Randwick Local Planning Panel (Public) Meeting

Development Application Report No. D18/25

Subject: 1 Mount Street, Coogee (DA/59/2025)

Figure 10: Council markup of GFA basement plan (Source: Fyffe Design with Council markup)

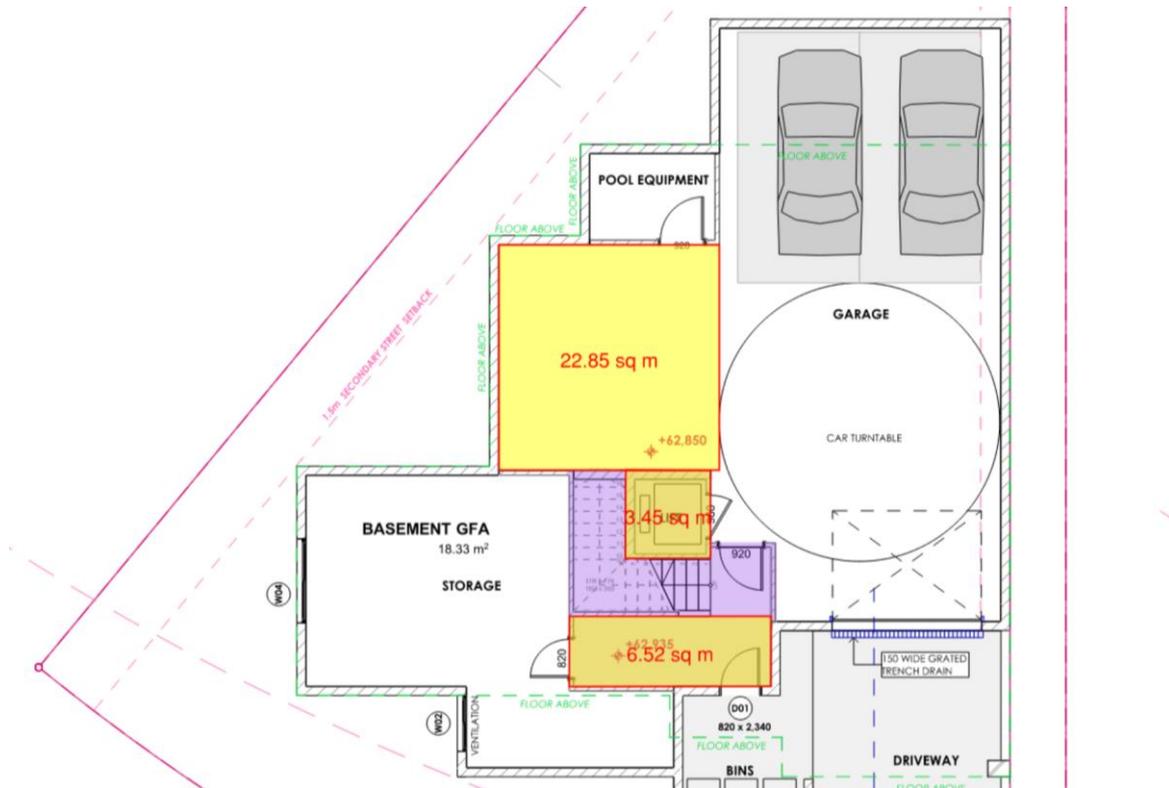
Council is not satisfied that the submitted gross floor area (GFA) plans are correct for the basement level. The area to the north of the car turntable does not constitute access to car parking and so should be included as GFA. The submitted swept path diagrams demonstrate that this area is not required for manoeuvring cars in/out of the basement in a forward direction.

Notwithstanding, the area of the internal stair and landing can be excluded at basement level as it constitutes access to car parking. Based on Council’s calculations (refer yellow highlight at Figure 10), 32.82m² of GFA is proposed at basement level.

The proposed total GFA of 302.81m² equates to a floor space ratio (FSR) of 0.739:1, which complies with the maximum 0.75:1 development standard.

Figure 15: Mark-up of south elevation plan (Source: Fyffe Design)

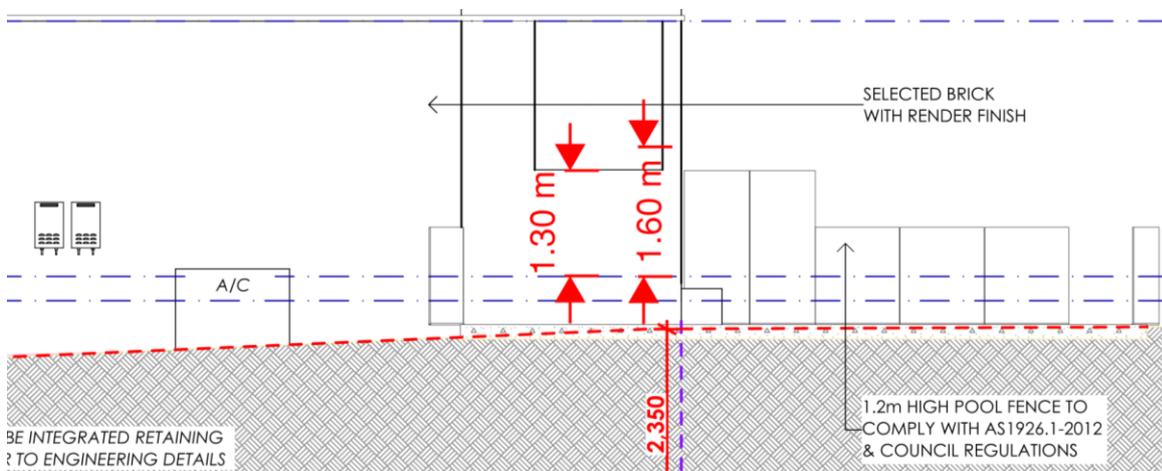
Concern is raised regarding potential overlooking from the proposed south-facing windows (at first floor level) to the property at No. 3 Mount Street. In accordance with the DCP requirements, a condition is included to ensure that raised sill heights (1.6m above FFL) or privacy glazing/screening is provided to Windows W30, W31, W32, W33, and W34.

Concern is raised regarding potential overlooking from the rear deck at ground floor level, which is raised above existing ground level. As such, a condition is included to ensure that the southern wall is raised from 1.3m (as proposed) to a minimum of 1.6m above FFL (refer to Figure 15).

Figure 16: Overlay of ground floor plan (red) and survey plan (green) (Source: Fyffe Design and G&R Surveying Services)

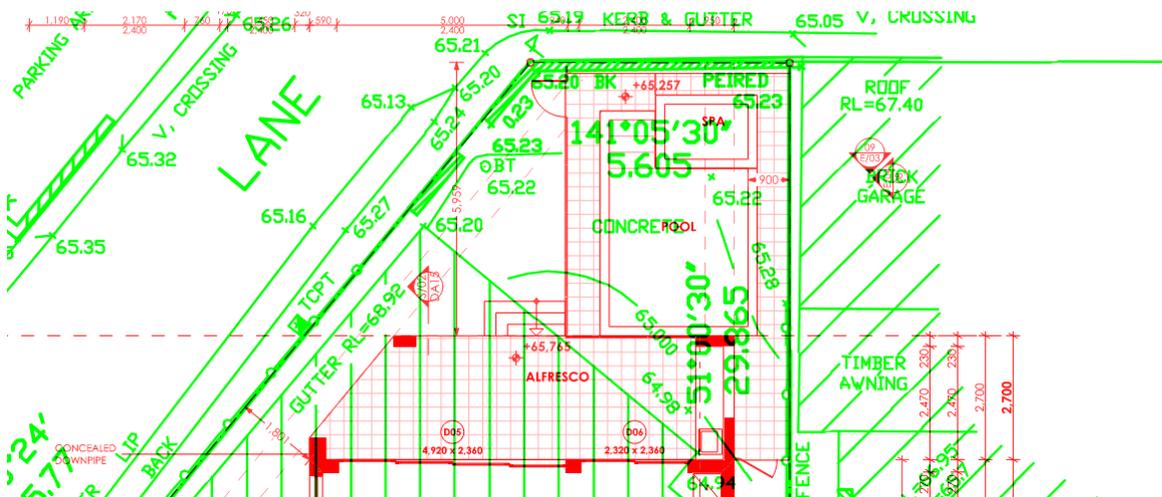
As shown in Figure 16, the rear pool (and associated decking) directly adjoins a garage at No. 3 Mount Street. The existing garage will suitably screen the pool and deck from the rear yard at No. 3 Mount Street.

Figure 17: Existing view corridor from No. 1A Mount Street (Source: Fyffe Design)

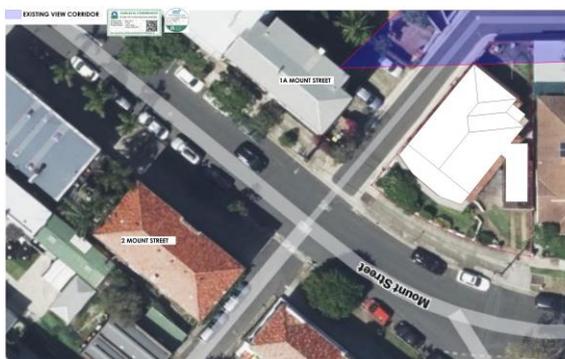
As shown in Figures 17-18, existing views from apartments at No. 1A Mount Street will be uninterrupted by the proposed development. In fact, noting that the proposed dwelling provides an increased rear setback (relative to the existing dwelling), additional view corridors may be afforded to these apartments.

Additionally, it is noted that there are no south-facing window or balcony openings at No. 1A Mount Street which directly overlook the subject site. The east-facing openings are generally oriented away from the subject site.
